DEVIATION REQUEST AND DECISION FORM

Project Name :	The Commons at Falcon Field	Deviation No. 2a - Rev. 4/3/2024; 2/9/2024; 11/27/2023 (Note: was previously part of Deviation 2 dated 6/2/2023)
Schedule No.(s) :	4307000001 and 4307200015	
Legal Description :	<p>TRACT IN SEC 7-13-64 DESC AS FOLS: BEG AT NW COR OF LOT 13 ARROWHEAD ESTATES FIL NO 1; TH S 00<46'12" W 197.28 FT ALG WLY LN OF SD LOT 13 TO A PT, N 41<58'50" W 798.01 FT TO SELY R/W LN OF US HWY 24, TH ALG SD SELY R/W LN ALG ARC OF CUR TO L SD CUR BEING CONCAVE TO NW HAVING A RAD OF 5800.00 FT AN ARC DIST OF 193.53 FT A C/A OF 01<54'42" WHICH CHORD BEARS N 47<22'56" E 193.52 FT, N 46<25'11" E 760.04 FT TO INTSEC SD SELY R/W LN OF US HWY 24 & WLY R/W LN OF RIO LN, TH SLY ALG SD R/W OF RIO LN S 22<22'28" E 219.81 FT, S 89<10'21" E 1071.23 FT TO NW COR OF LOT 14 OF FALCON RANCH ESTATES SUB, S 00<10'51" E 705.04 FT ALG WLY LN OF SD LOT 14 & LOT 13 FALCON RANCH ESTATES SUB TO THE MOST NLY NW COR OF LOT 10 ARROWHEAD ESTATES FIL NO 1, TH CONT S 00<10'51" E 151.74 FT, TH N 88<55'44" W 1314.29 FT TO POB</p> <p>TRACT IN SEC 7-13-64 DESC AS FOLS: COM AT NW COR OF LOT 13 ARROWHEAD ESTATES FIL NO 1; TH S 00<46'12" W 197.28 FT FOR POB; TH

Deviation Exhibit A

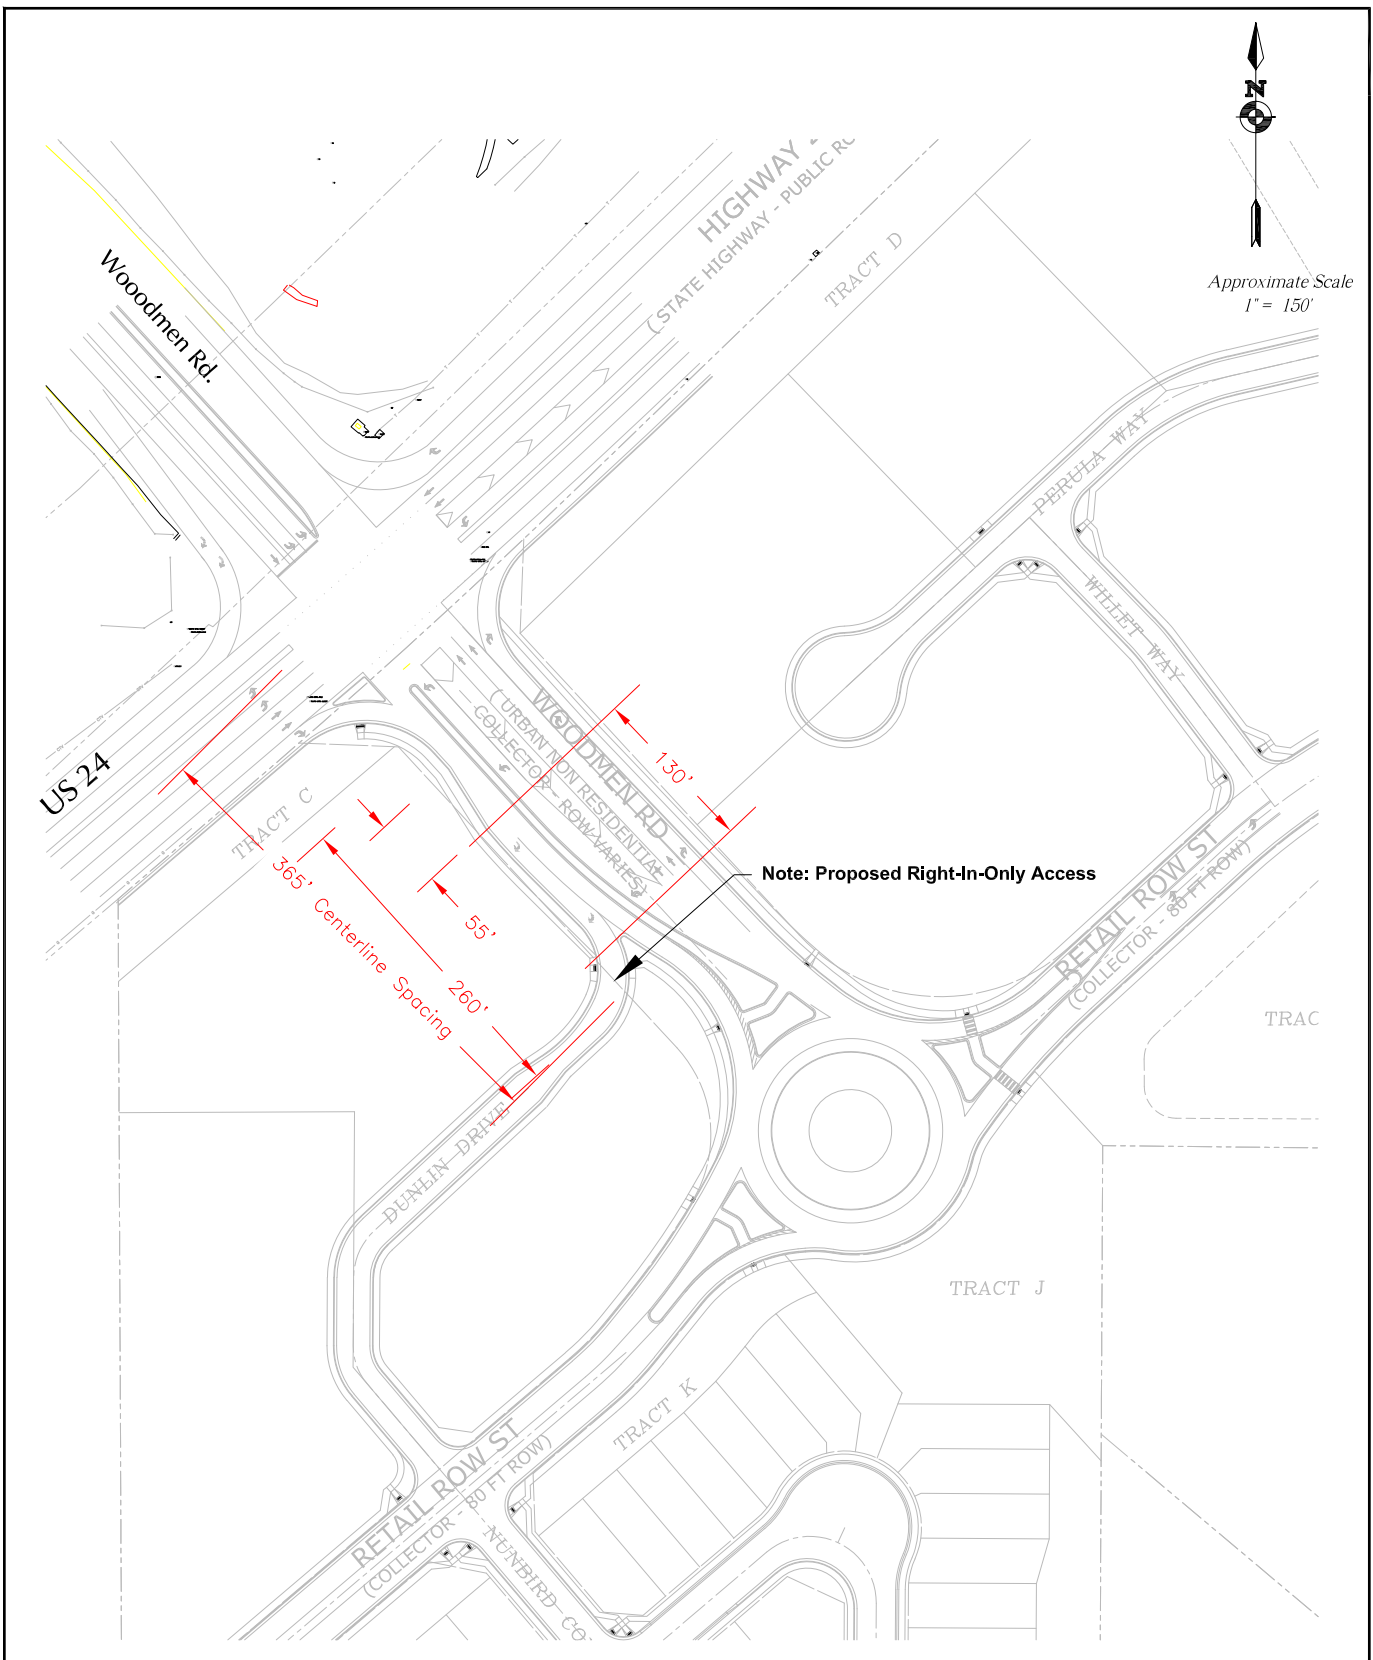
This deviation is one of four submitted with this application. Deviation Exhibit A (attached) graphically summarizes all four deviation requests, including this one. This requested access point (driveway) is shown on this exhibit. Deviation Exhibits 2a-1 and 2a-2 and AutoTurn Exhibit No. 4 are also attached and are referenced below.

Note: Proposed Right-In-Only Access

Deviation Exhibit 2a-1

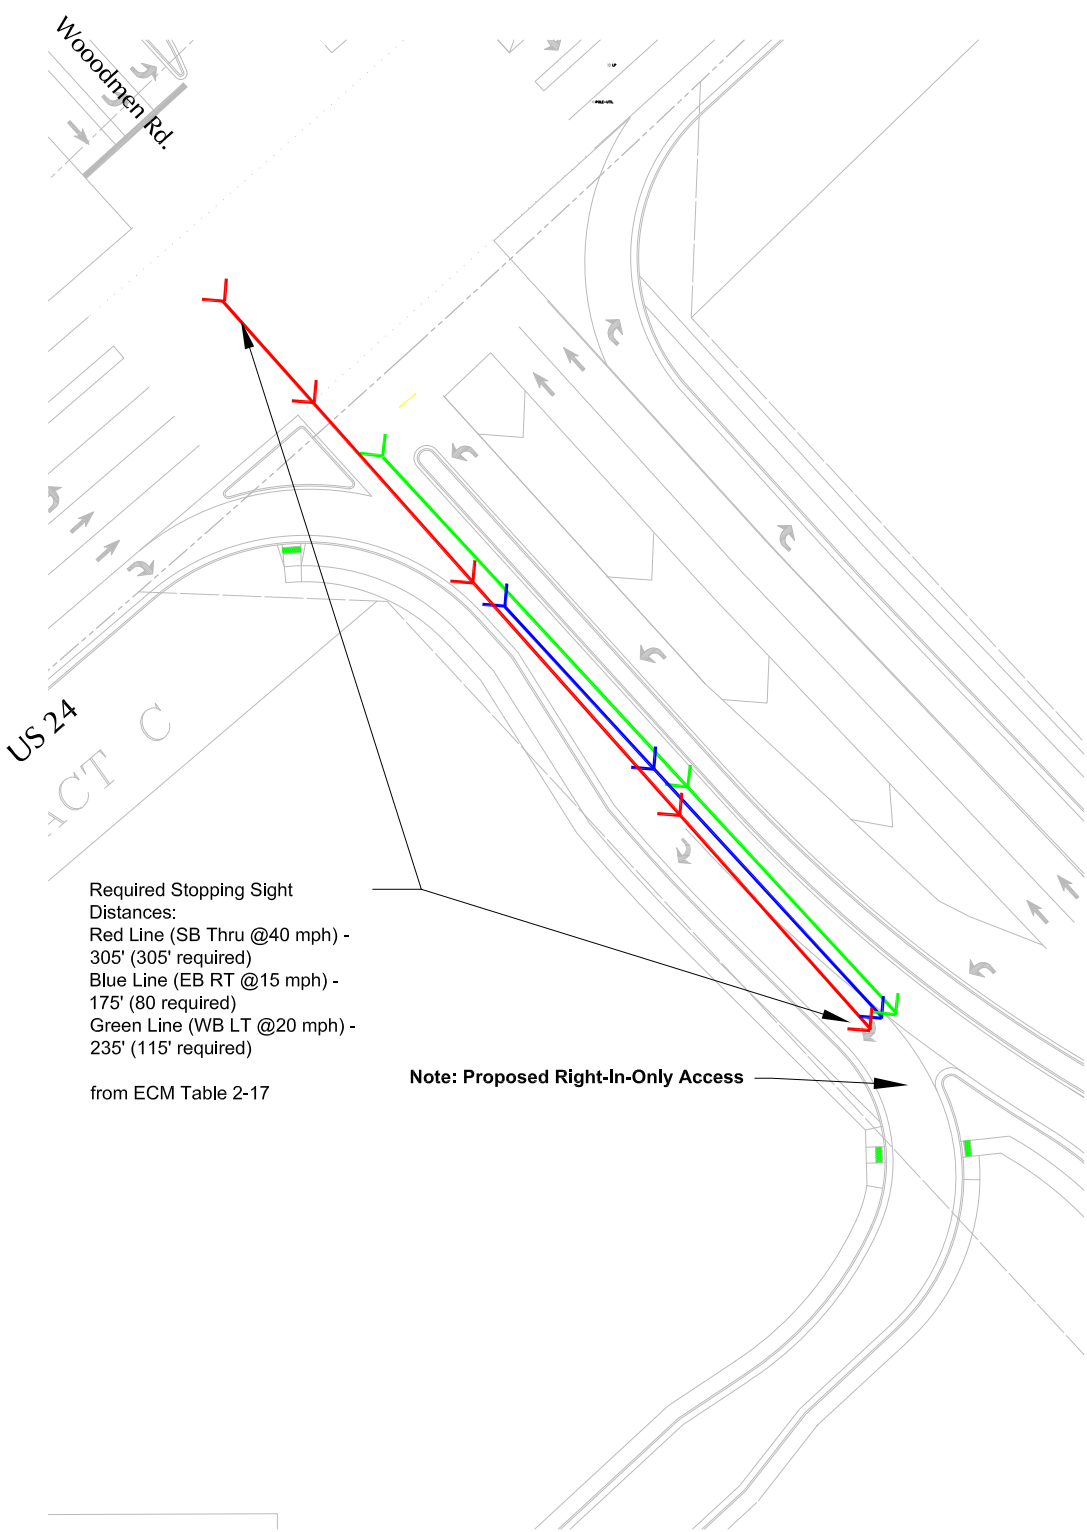
The proposed right-turn lane would have abbreviated lane and taper lengths. The ECM standard is 155-foot lane plus 160-foot taper, plus storage. Deviation Exhibit 2a-1 shows the proposed lengths. The lane would be about 130 feet plus a 55-foot bay taper. The abbreviated length will be mitigated by the proposed 50-foot corner radius. Please refer to Deviation No. 3, which addresses turn lane design.

Note: Proposed Right-In-Only Access
